REMARKS/ARGUMENTS

Appl. No. 10/776,663 Amdt. dated Reply to Office action of September 08, 2006

FIG. 1

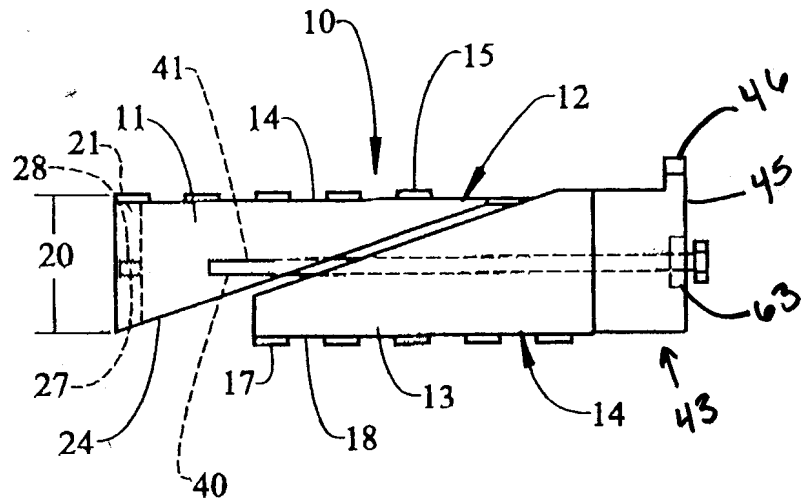
Lastly, Applicant do not agree with the Examiner's determination that the "link (40)" as specified in original claims 3, 8 is not shown in the drawings. Applicants point the Examiner's attention to Fig. 1, as originally filed, and the original specification at page 9, lines 3-17.
